To: T10 SAS Protocol Working Group

Subject: ~~SAS-2.1~~[SPL](#): 08-249 Link Layer Power Management

This proposal is a complement to 08-015 [and 08-206](#). This proposal focusses on link layer changes to support lower power modes.

Figure 120 — SL (link layer for SAS logical phys) state machines (part 23)

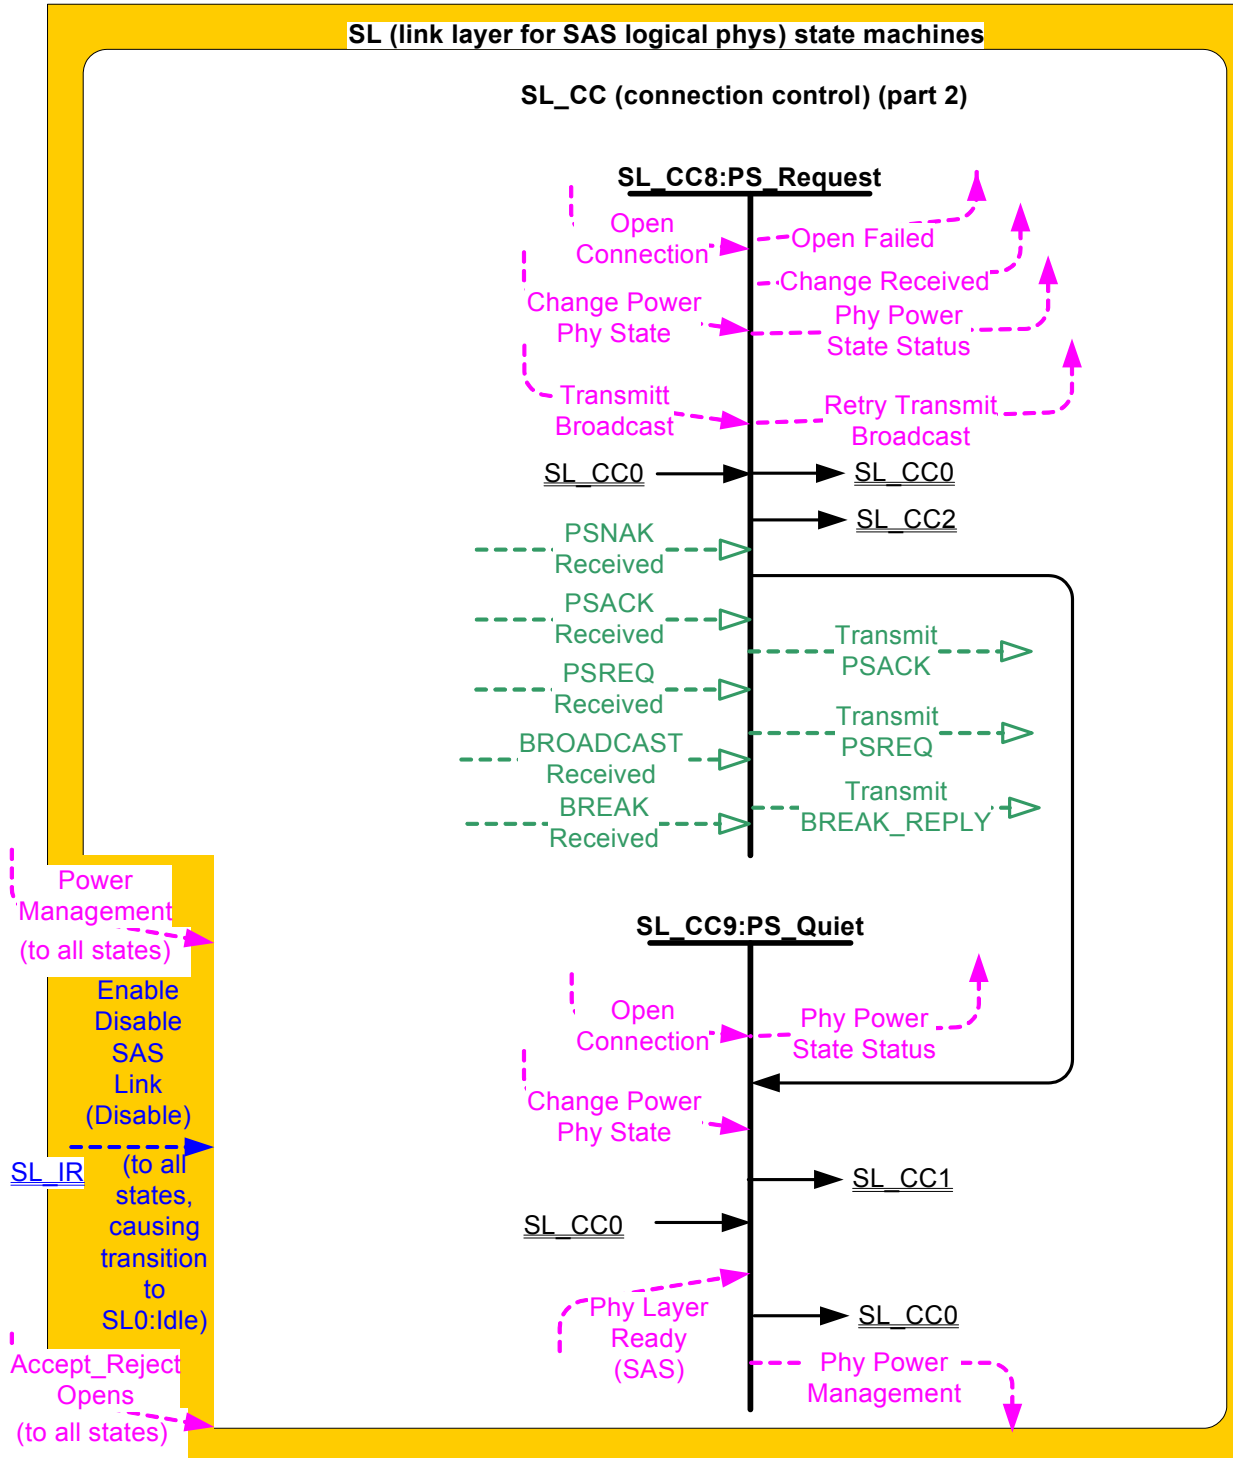
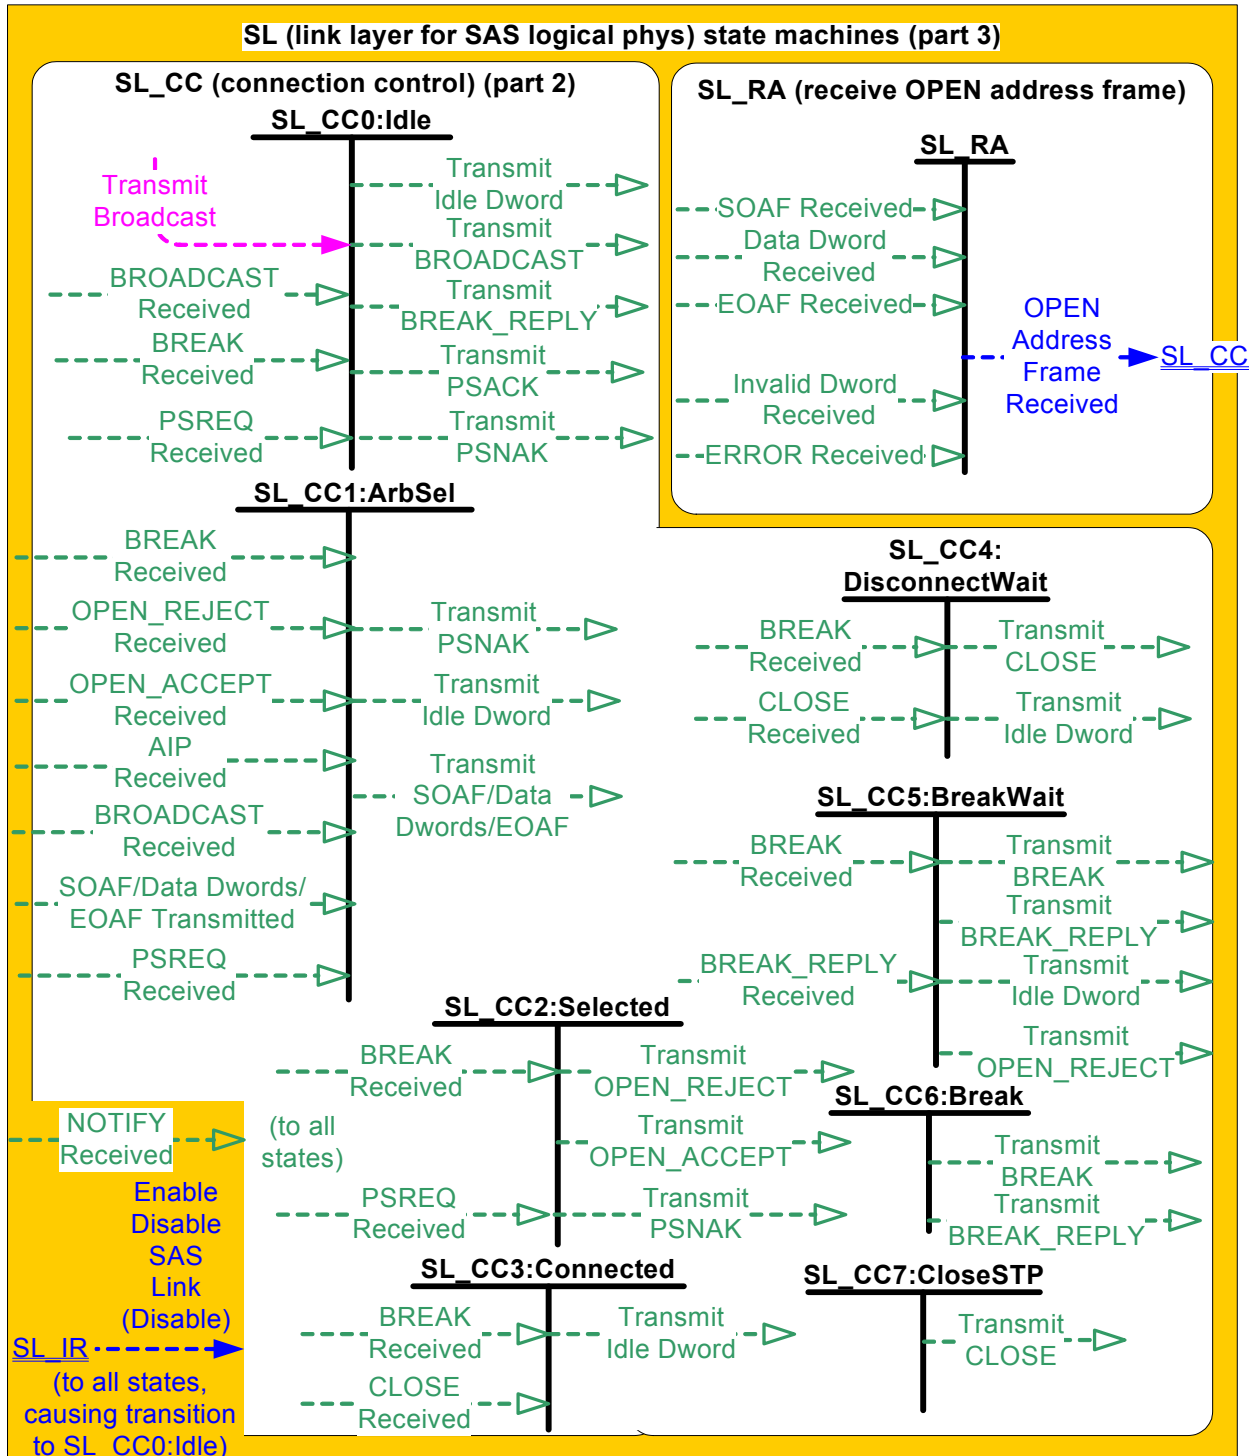
[Editor's Note 0: Need to update figures with new states, and with Request Power Management request coming down, and Phy Power confirmation coming up.](#)

Figure 121 — XL (link layer for expander logical phys) state machine (part 1)

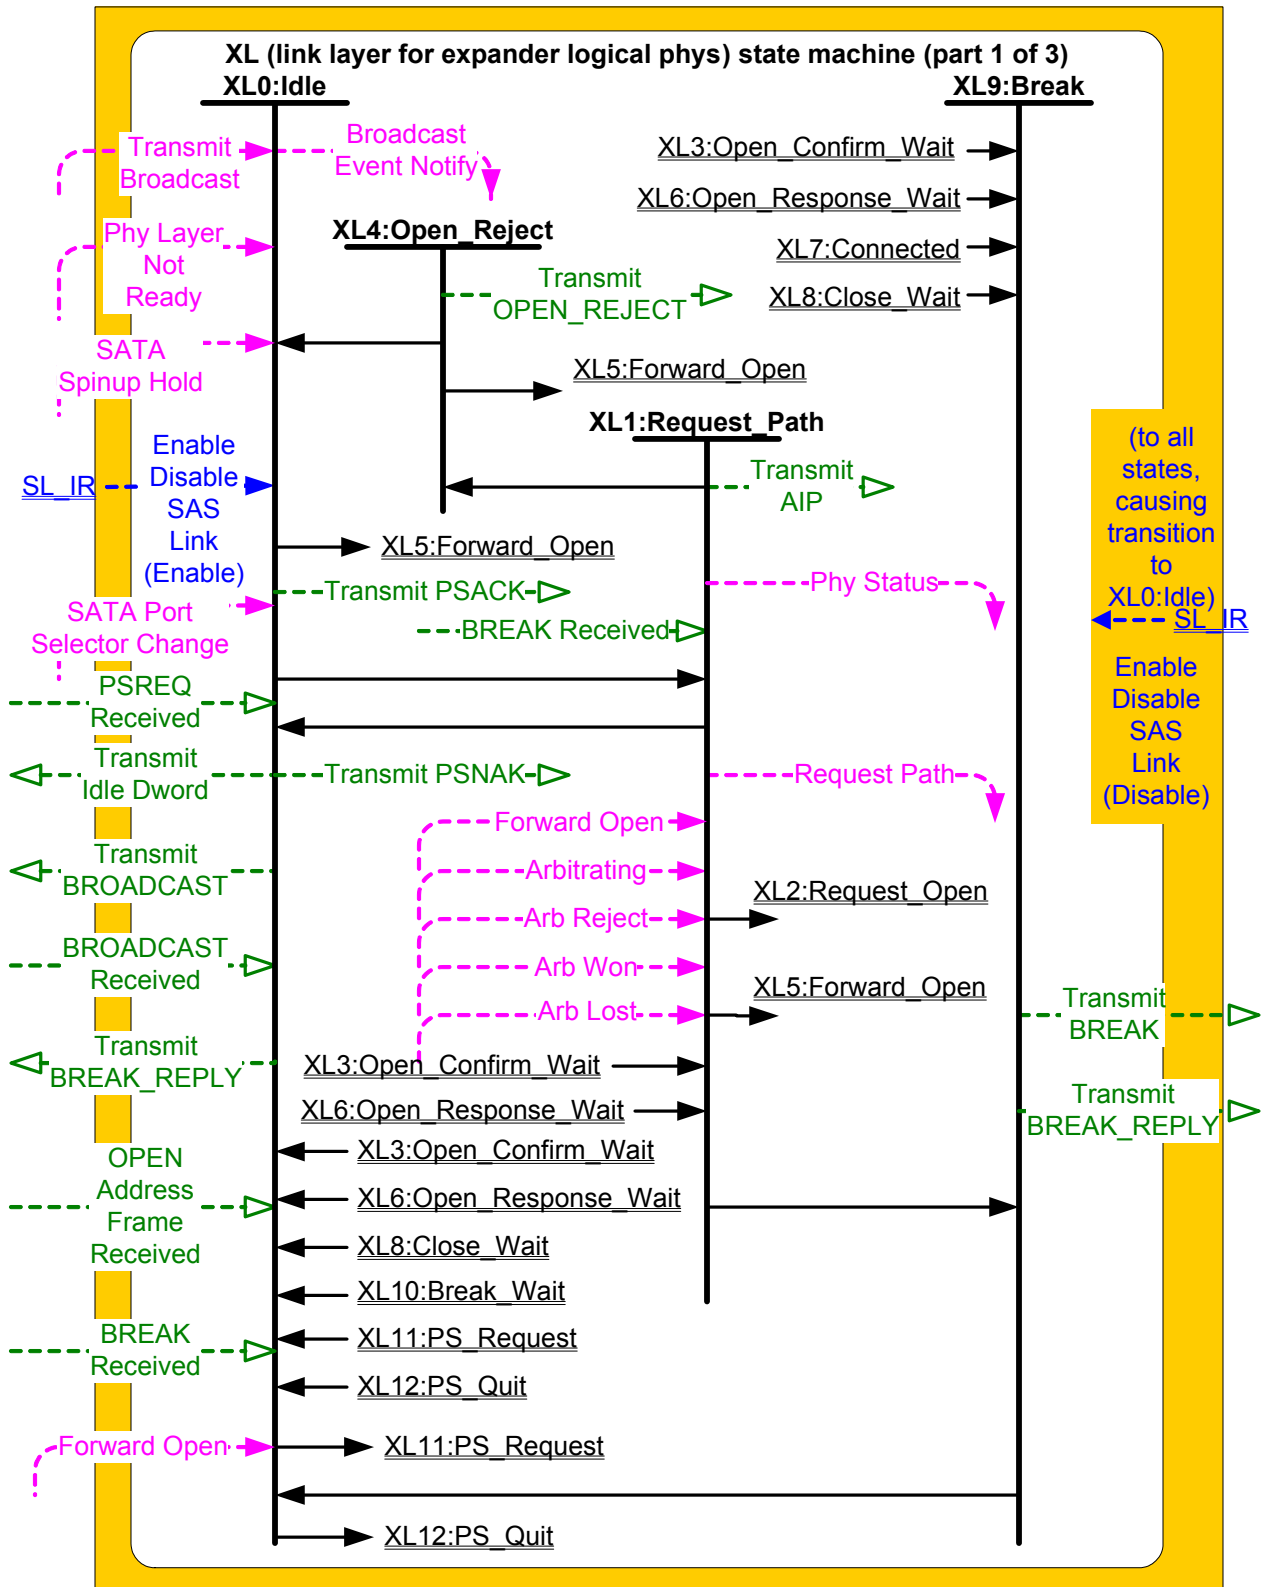
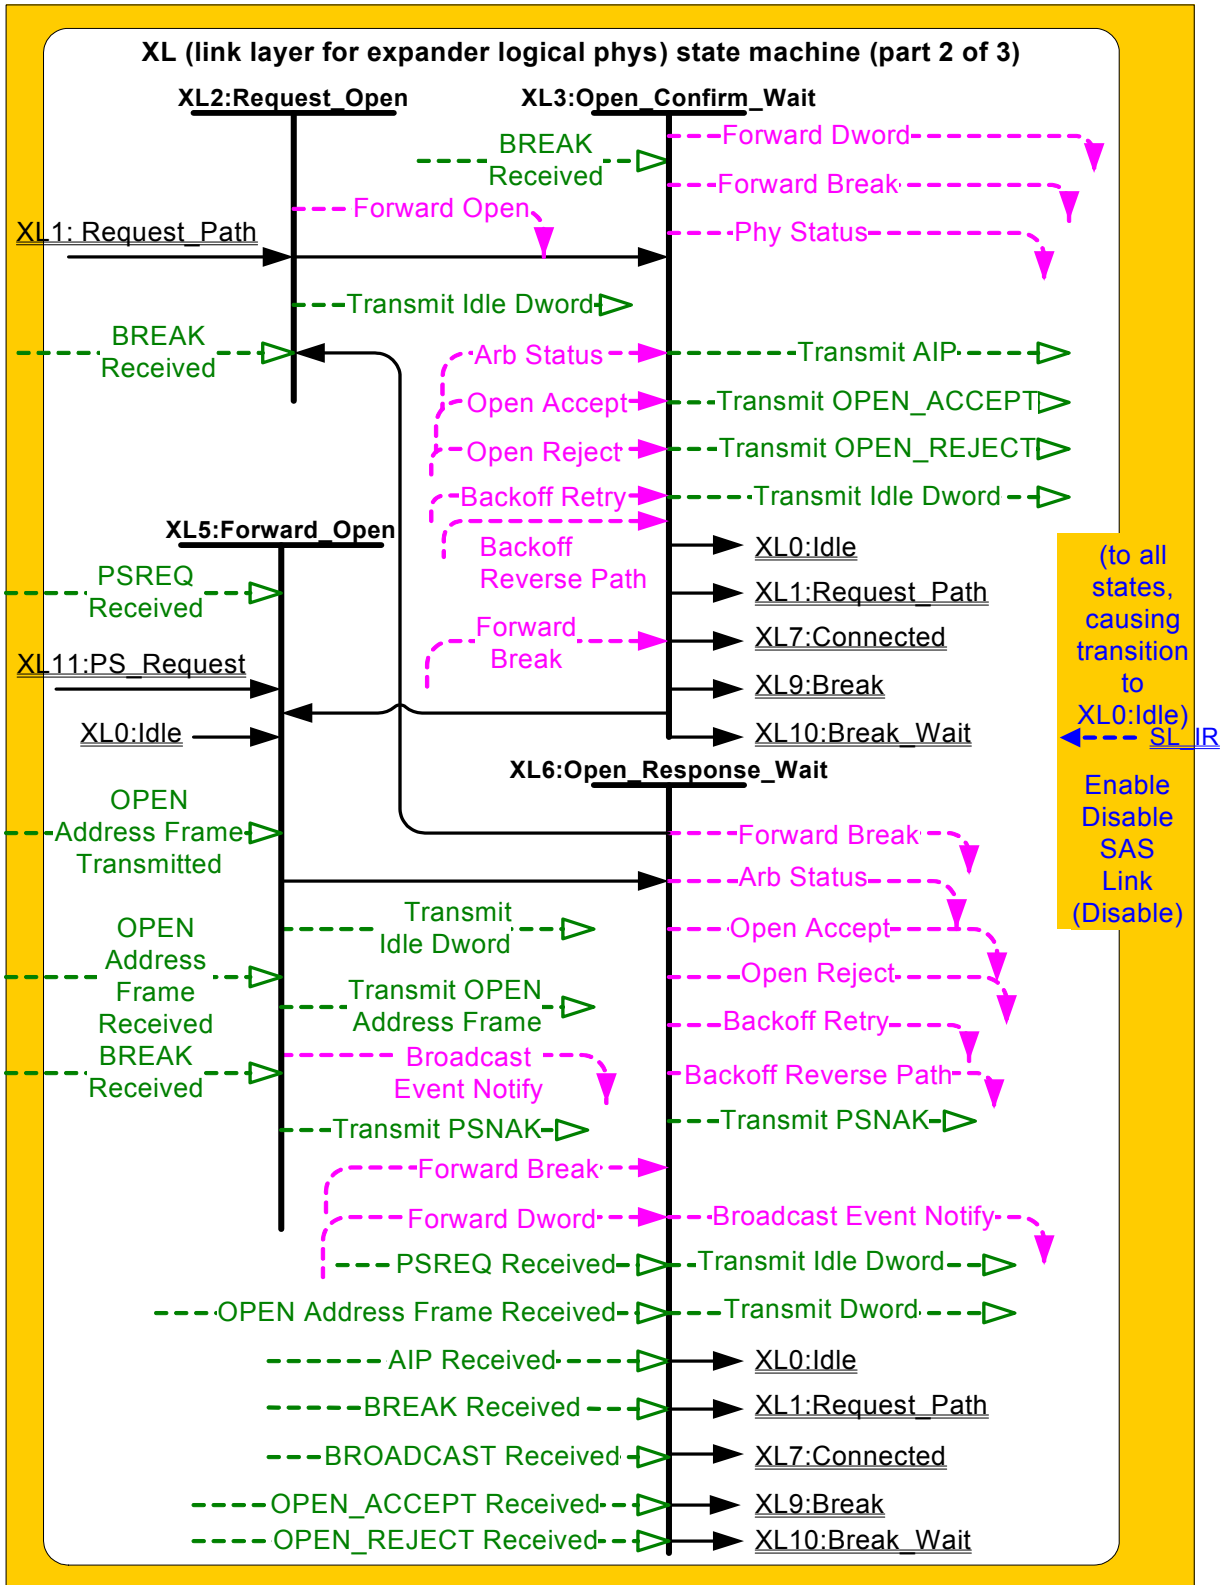
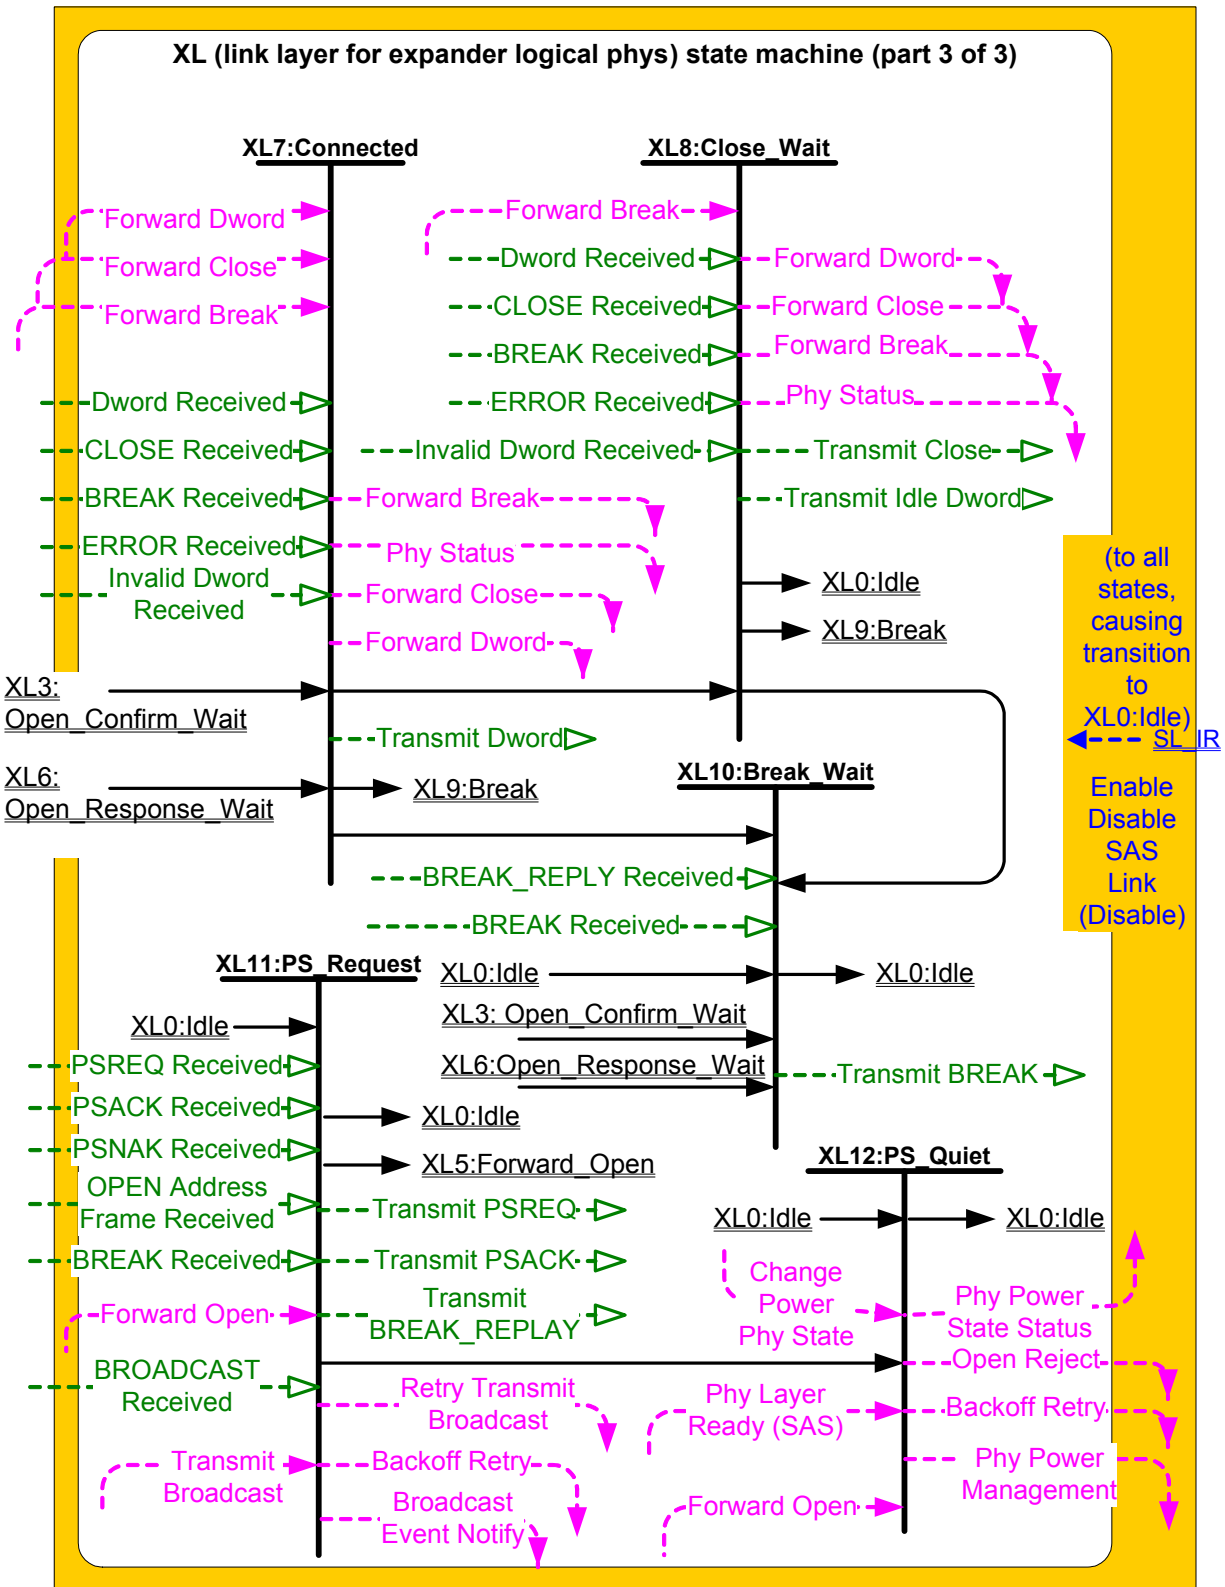
Editor's Note 11: Need to update figures with new states, and with Request Power Management request coming down, and Phy Power confirmation coming up.
